Application Number: 08/997,368

Filing Date: 12/23/97 Appellant(s): Himuro

EXAMINER'S ANSWER

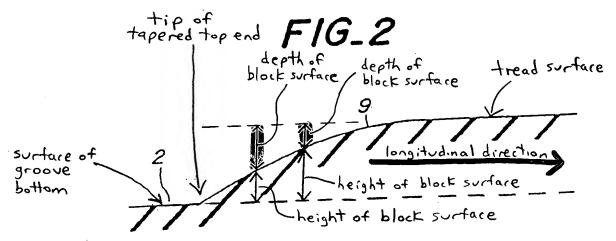
With respect to chamfering, applicant argues, for the first time, that the tapering (chamfering) in Japan '718 and Japan '025 is "reversed to that required". (Brief page 5 last line).³ The examiner disagrees. FIRST: Appellant's description of the tapering of the invention in the Brief filed 5-3-00 is inconsistent with that disclosed in appellant's original disclosure and appellant's claims. See above noted disagreement with the appellant's Summary of the Invention. SECOND: Japan '718 and Japan '025 suggest the same chamfering as claimed and disclosed by appellant. Below is a modified copy of figure 2 of Europe '718:

The text in the above modified figure 2 of Europe '718 has been added by the examiner. As can be seen from the above modified figure 2 of Europe '718, the <u>height</u> of the block surface increases in the longitudinal direction from the surface of the bottom of the groove to the tread surface whereas the <u>depth</u> of the block surface decreases in the longitudinal direction from the

surface of the groove bottom to the tread surface. In Europe '718, Himuro describes this surface in terms of height instead of depth but the same chamfering as that claimed in claim 1 is being described.
